TO SCAME CLIENTS

List of new available products

LIBERA Series

• COMMUNICATION OF MODIFICATION

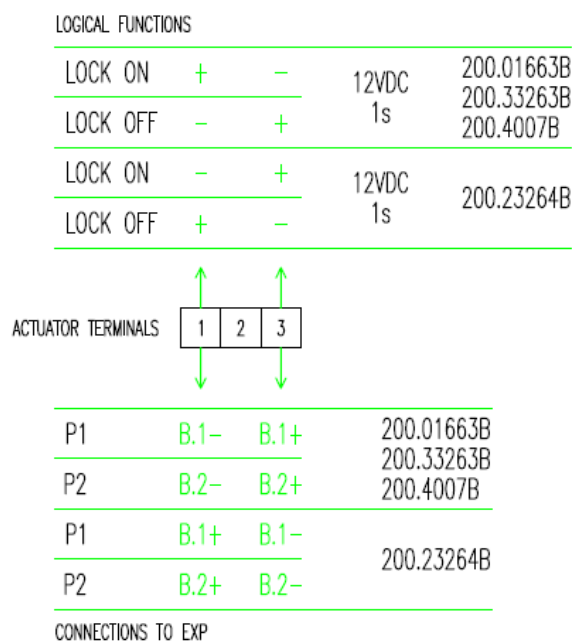
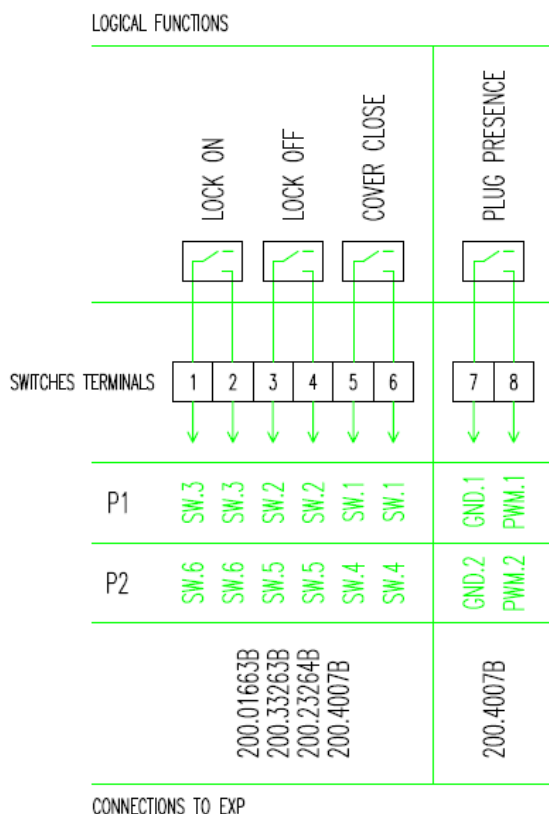
Scame Parre S.p.A. informs that, in order to standardize the wiring and to rationalize the test procedures, the socket-outlets with lock Type 3A (200.01663B), Type 3C (200.33263B), Type 2 (200.23264B) and Unel (200.4007B) have been modified.

The modification consists in:

- Signal repositioning on the terminal strip as 200.23264B (see attached diagram).
- Switching from 0.75 to 0.5 mm² conductors for switch connections (0.75 mm² conductors will be used until exhaustion).

The modification doesn't affect the socket-outlet working, nor its management, that remains unchanged.

The modification will affect all the items produced from 05.05.2014 for which the instruction sheets will be updated to the new wiring.

The modification will not be retroactive therefore all the items in stock on that date will be provided, subject to availability, with the previous wiring.

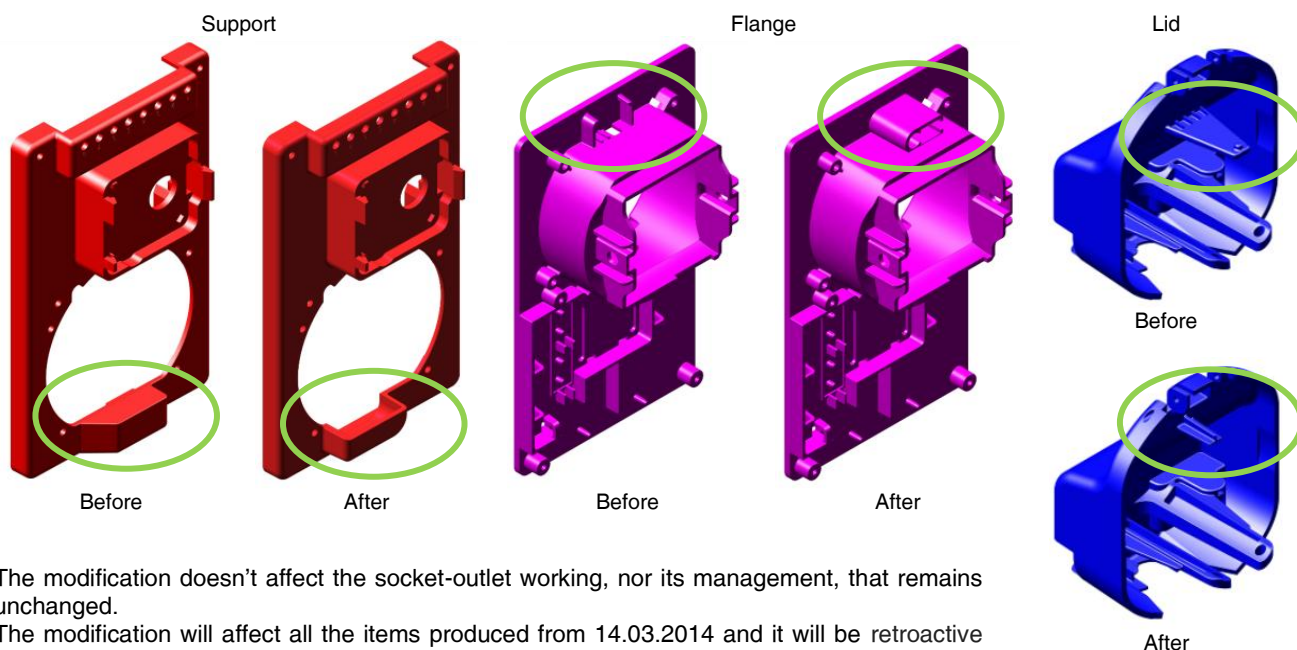
Scame Parre S.p.A. informs that, in order to guarantee the interoperability with maximum number of Schuko plugs today on market, the UNEL socket-outlet with lock (200.4007B) has been modified. The modification consists in the resizing of the micro switch pushing flap placed on lid (that didn't allow the lid closing in case of angled plug) and consequent replacing of micro switch.

The modification doesn't affect the socket-outlet working, nor its management, that remains unchanged. The modification will affect all the items produced from 14.03.2014 and it will be retroactive therefore all the items in stock before this will be changed.
